Request For Information

Project Name: Replace Roofs (Program Phase 1 - 4)

Title: Roof Replacement - Phase 1 Facility B

RFI#: 006

2 SPECIAL CONDITION - 1

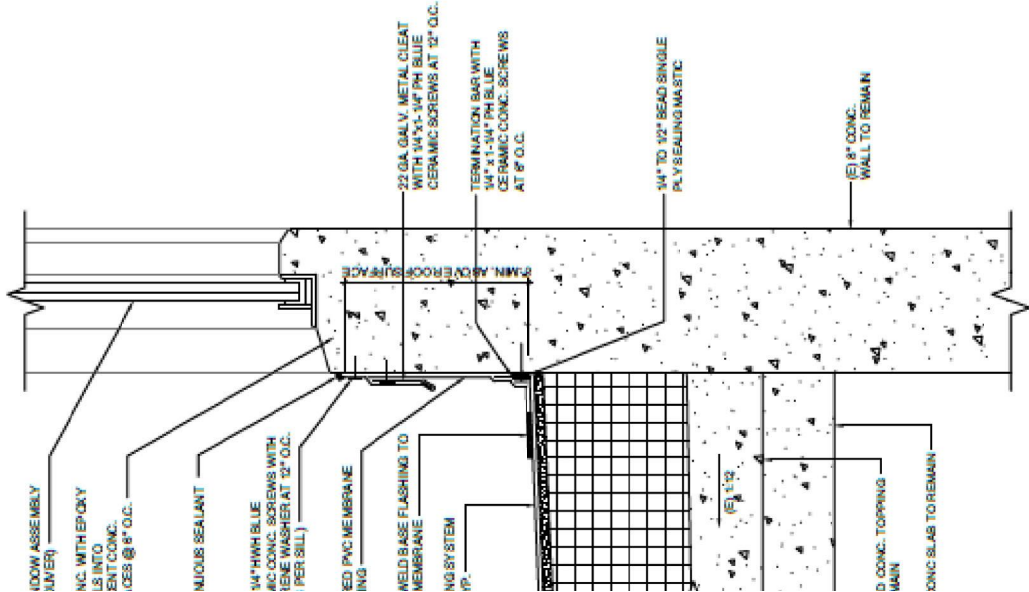
1. Plan Set 22-090 Plan sheet A3.9 Special Condition 1 and 4 shows to remove and replace existing windows. CCM Field wants to verify that glazing is to be replaced not windows. See attached drawings.
 2. CCM also wants to verify Detail 1 A3.9 will be used for Special Condition 1 and 4 per plan?
- Please Advise?

- REMOVE AND REPLACE (E) STAIRS. SEE 98.133 FOR ADDITIONAL INFORMATION
- REMOVE LANTANCE, PEELING PAINT, ETC. AND PREPARE SURFACE TO BE RE-PAINTED. PAINT ENTIRE WALL THAT CONTAINS WINDOWS
- REMOVE (E) WINDOWS AND REPLACE. FIELD DETERMINE DIMENSIONS

A CB will be issued once the consultant provides the corrected drawings.

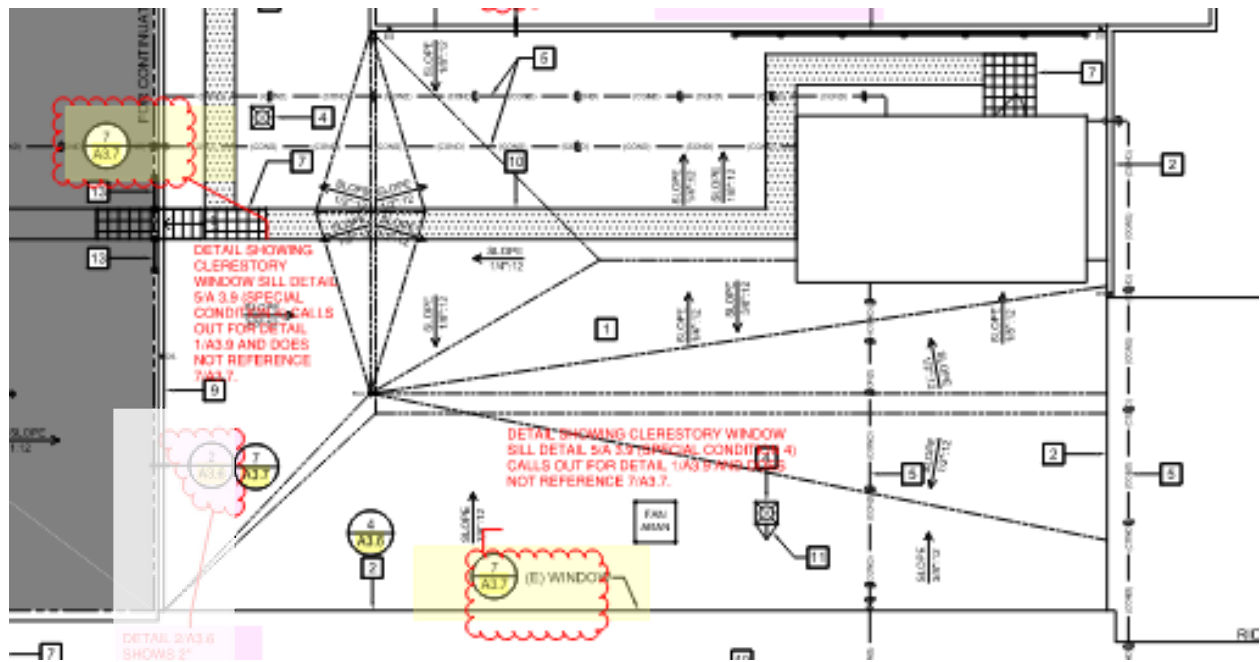
Figure 4: Snip from Sheet A2.6 showing demolition at Unit 2 roof. Detail 7/A3.7 is called out at existing clerestory window sill and at the section of wall with the existing louvers. Details at these conditions should be added/corrected. Detail 1/3.9 is referred to at this location on Sheet A3.9 but does it apply here? The details need to be corrected.

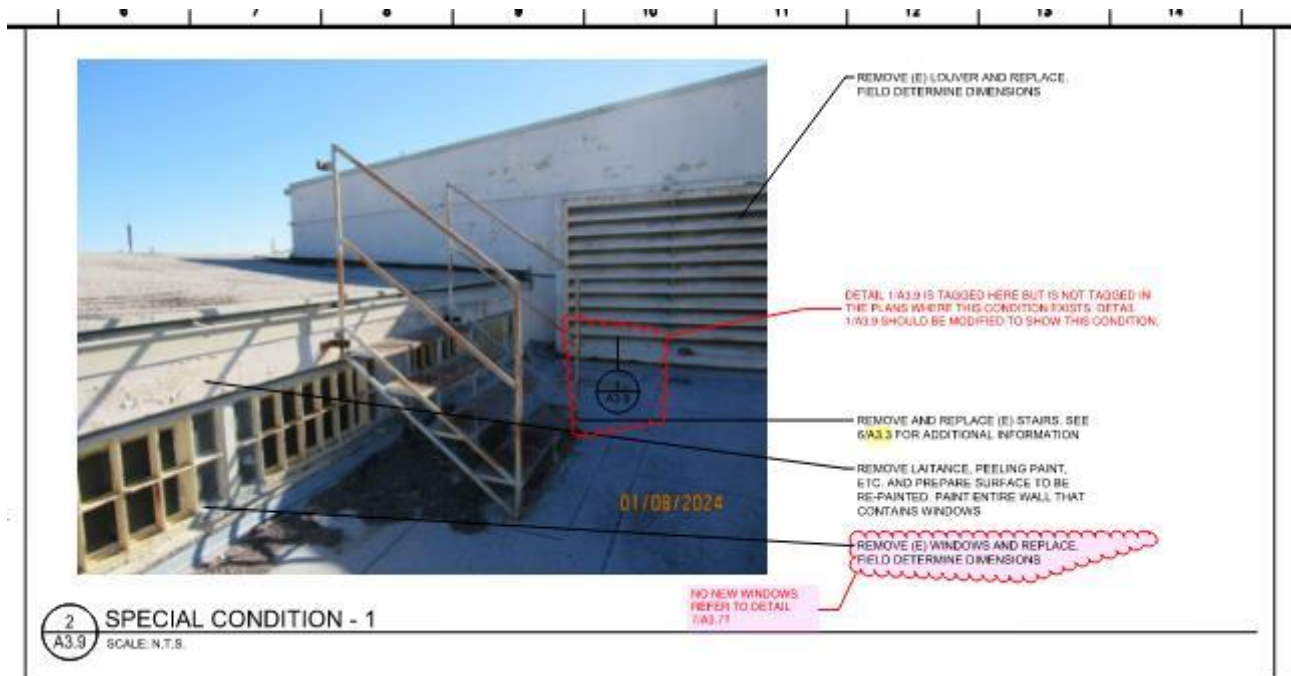
Figure 4: Snip from Sheet A3.9 showing detail 1/A3.9 tagged at louver wall. Detail 1/A3.9 needs to be modified to show louver condition. Does Detail 7/A3.7 should be tagged at clerestory window and any reference to removing and replacing windows should be removed. Glazing may need to be removed and replaced with steel plate per Detail 7/A3.7 but windows are not being replaced.

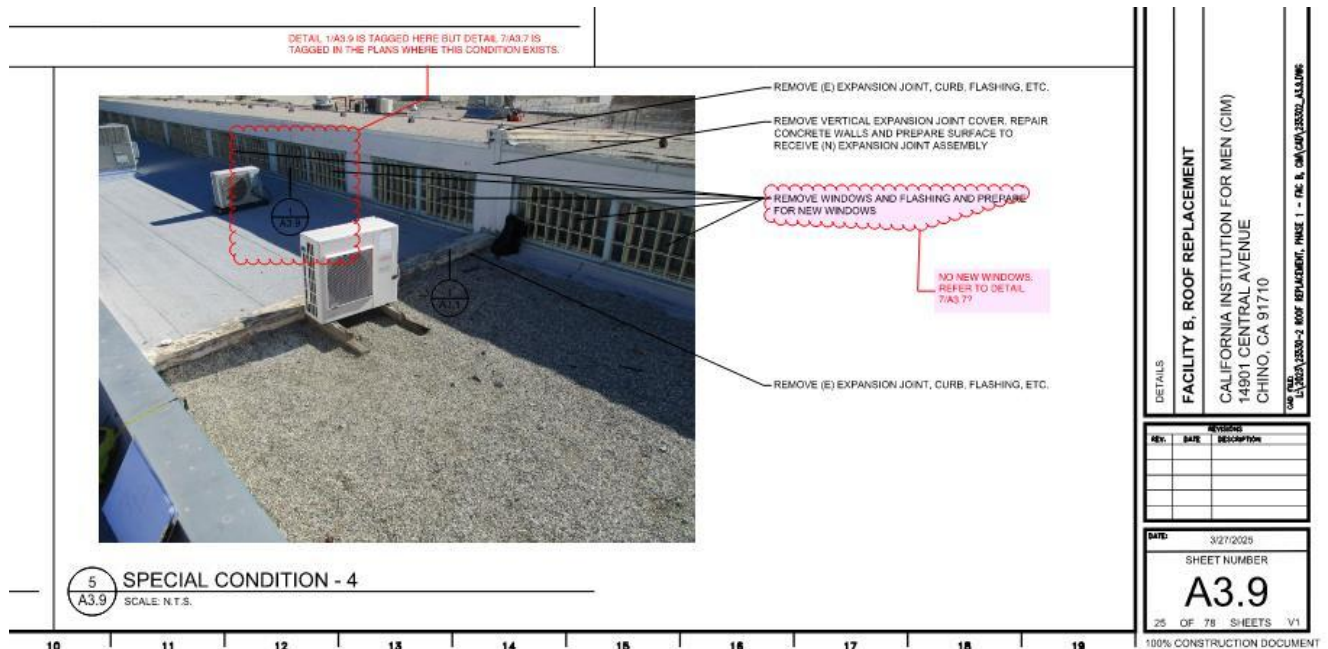
Figure 5: Snip from Sheet A3.9 showing detail 1/A3.9 tagged at louver wall. Detail 1/A3.9 needs to be modified to show louver condition. Does Detail 7/A3.7 should be tagged at clerestory window and any reference to removing and replacing windows should be removed. Glazing may need to be removed and replaced with steel plate per Detail 7/A3.7 but windows are not being replaced.

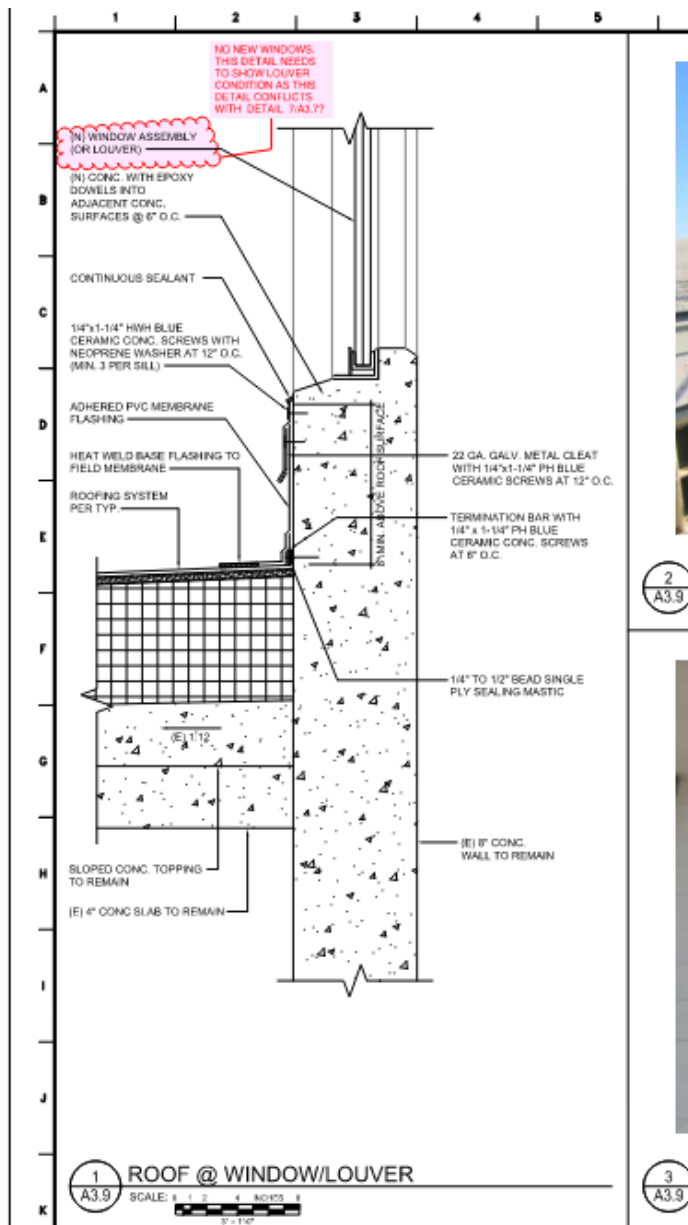
Figure 7: Snip from Sheet A3.9 showing Detail 1/A3.9. There are no new windows so references to this should be removed everywhere. This detail either conflicts with Detail 7/A3.7 or is redundant. There is no detail properly showing how existing louvers will be dealt with at new roof assembly. This detail should be corrected and tagged appropriately to represent the actual conditions and proposed new work.
